October 31, 2024

**Re: Nobis Rehab Hospital  
1100 Woodward PI NE  
Conceptual Traffic Circulation Layout for DFT Approval  
Engineer's Stamp 10-3-24 (J15D053)**

<b>NOBIS REHAB HOSPITAL</b> 1100 WOODWARD PL.	DRAWN BY pm
	<b>SITE PLAN</b>	DATE 10-3-24
	5571 MIDWAY PARK PL NE ALBUQUERQUE, NEW MEXICO 87109 (505) 858-3100 www.tierrawestllc.com	DRAWING 2023123-SP
RONALD R. BOHANNAN P.E. #7868	SHEET # <b>SP-1</b>	JOB # 2023123

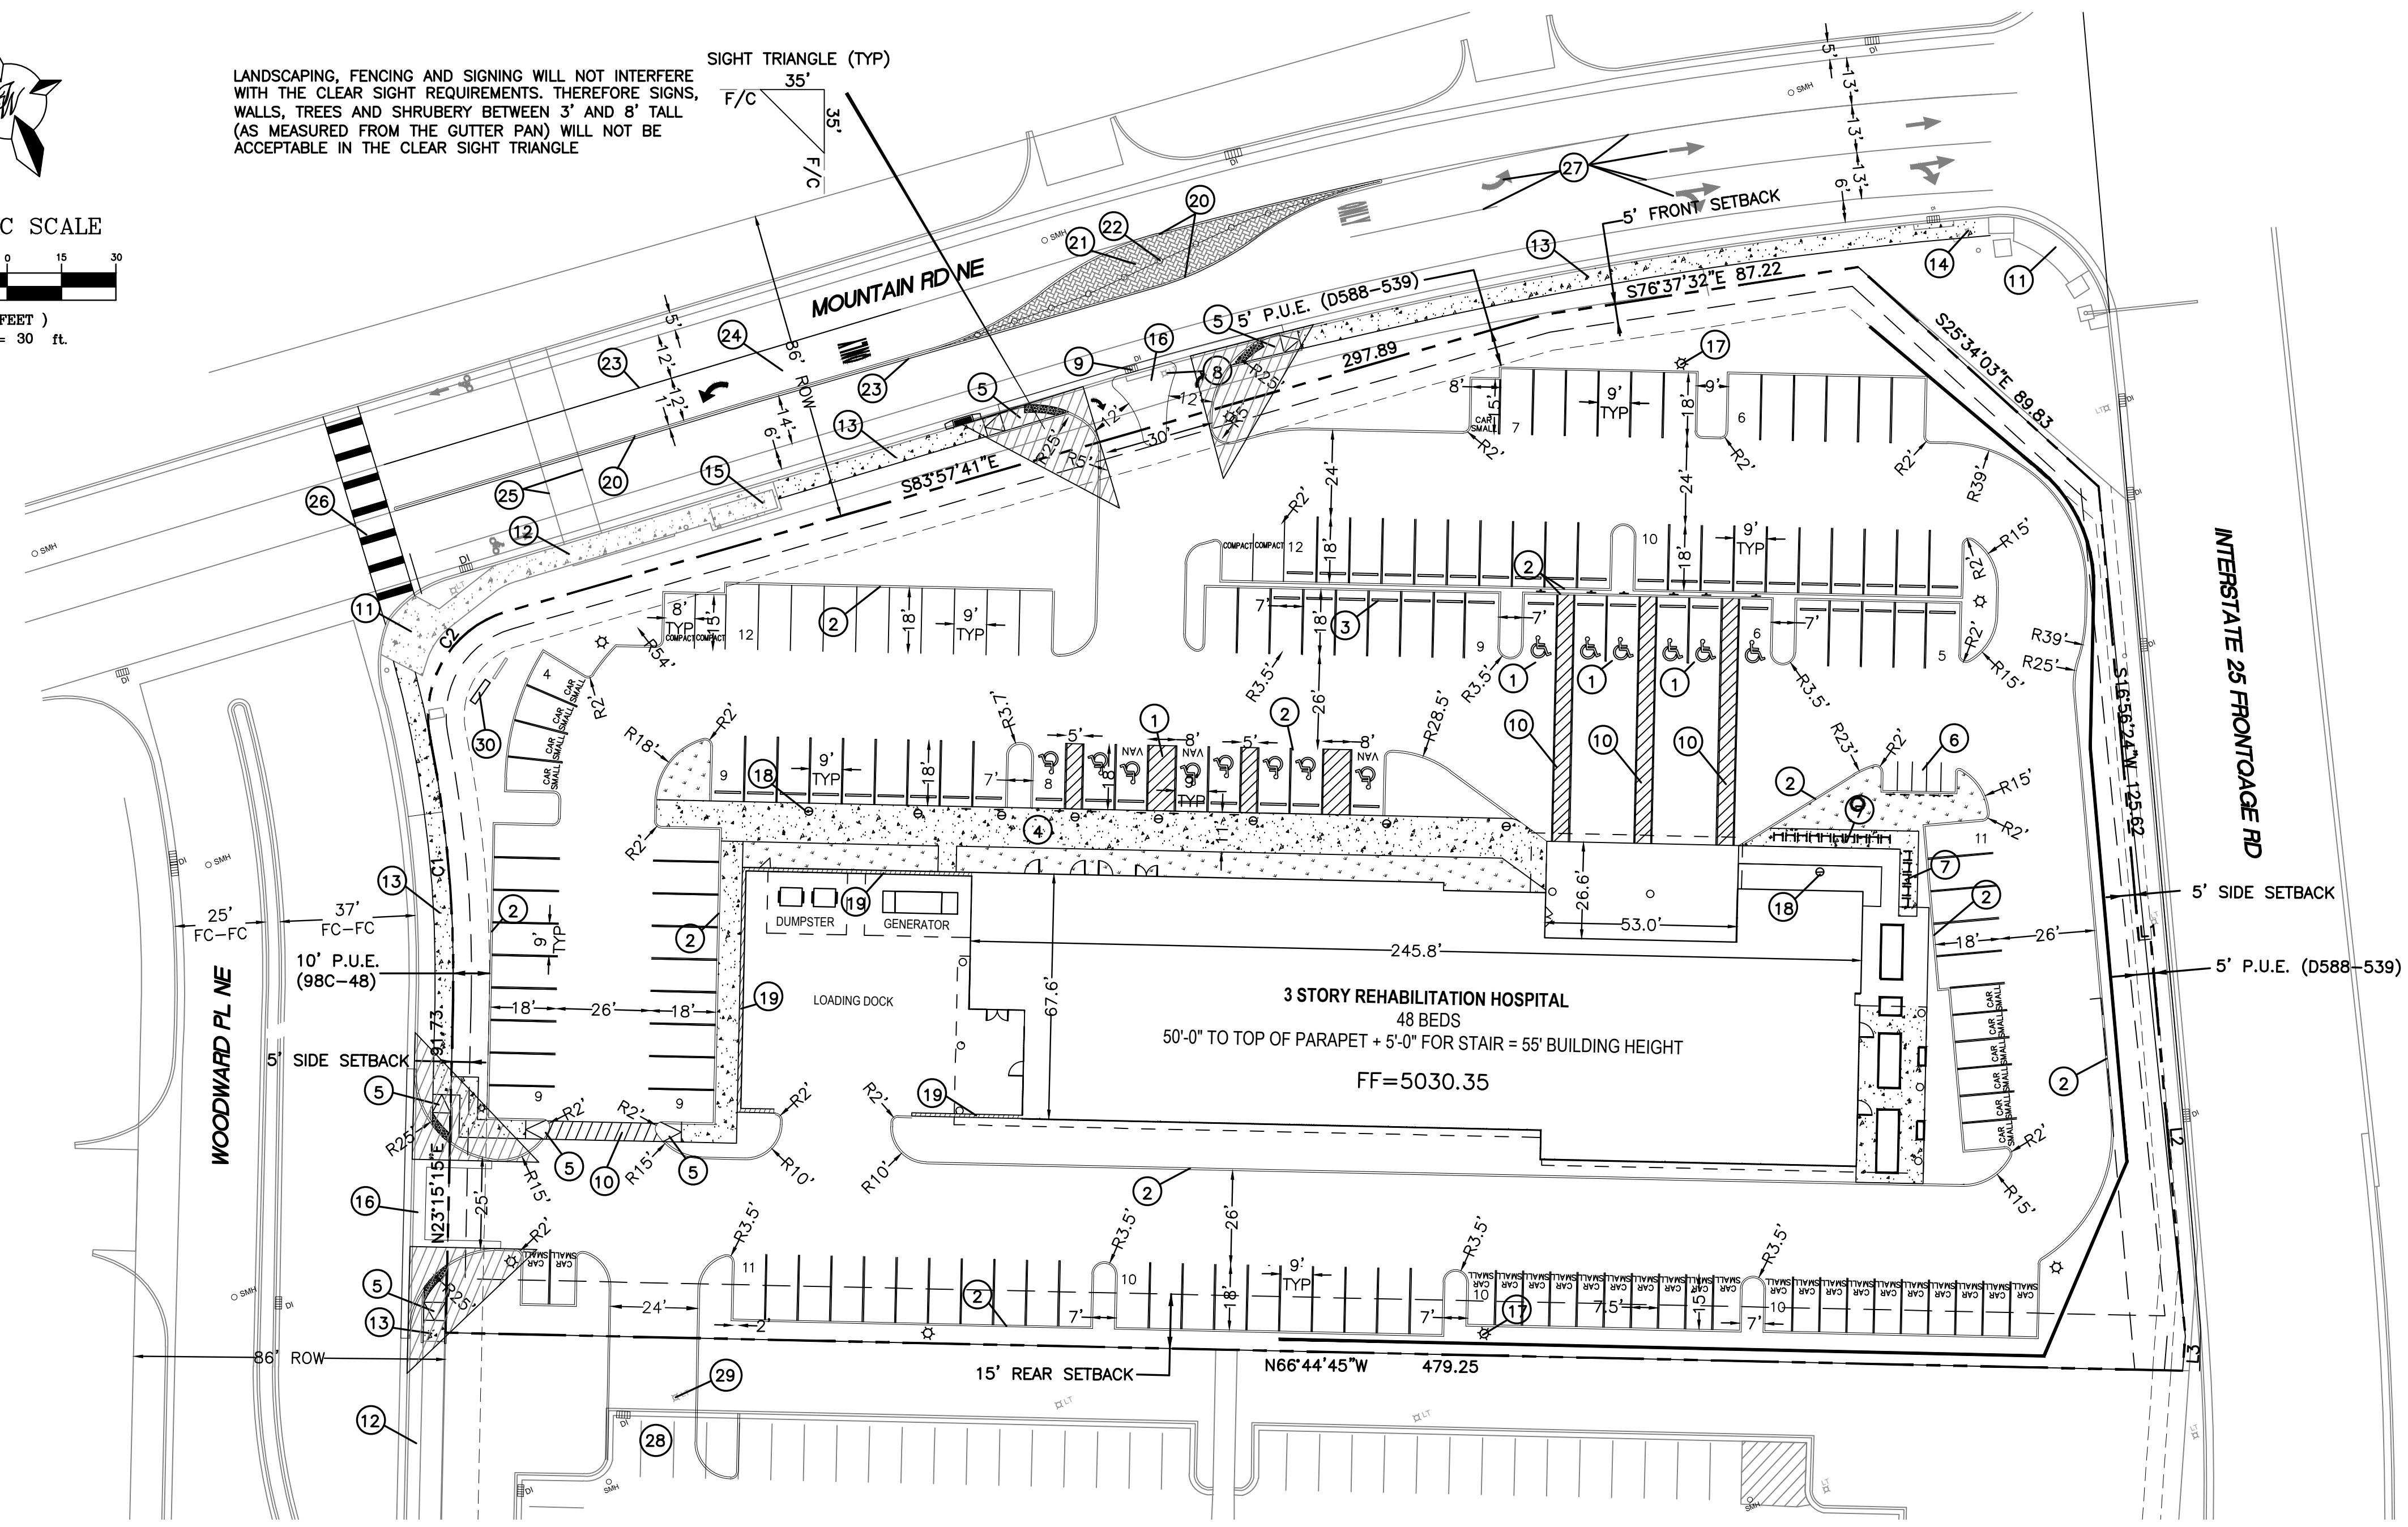
The conceptual TCL submittal received 10-17-2024 is approved for DHO and/or DFT submittal. When submitting this project through the building permit process, a full Traffic Circulation Layout will need to be submitted and approved prior to building permit. **When submitting TCL for building permit approval, please ensure that both site access details are provided and updated to meet the current ADA city standard.**

**SP-1**

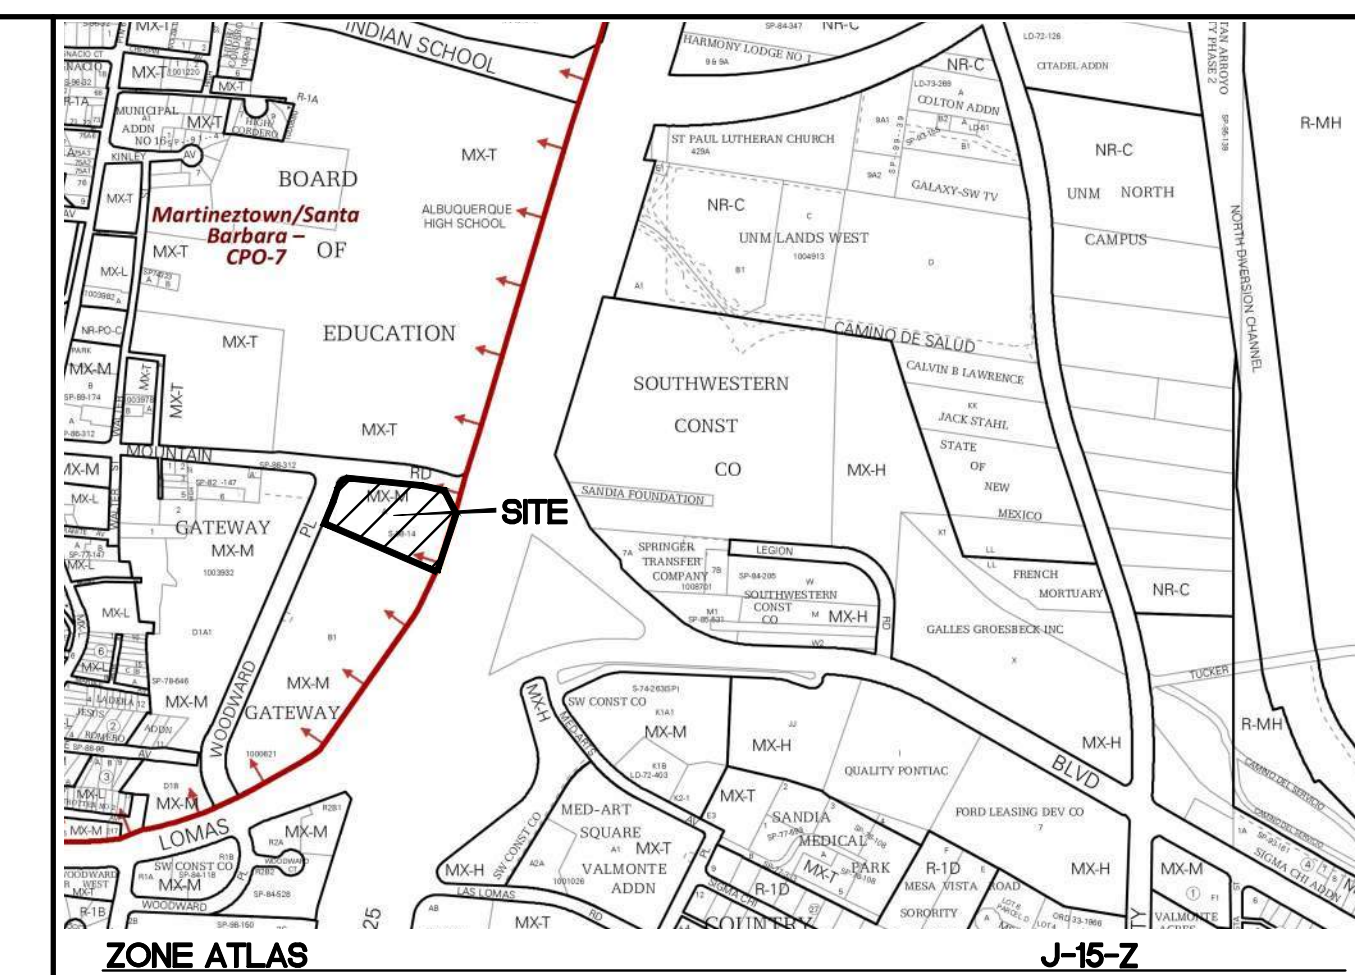
Approved for access by the Solid Waste Department. All containers must be made accessible for pick up between the hours of 5AM and 8PM.

**\*\*Hazard Route Only\*\***  
**\*\*Access will be granted to Solid Waste Department from the Woodward PI Side of this property\*\***
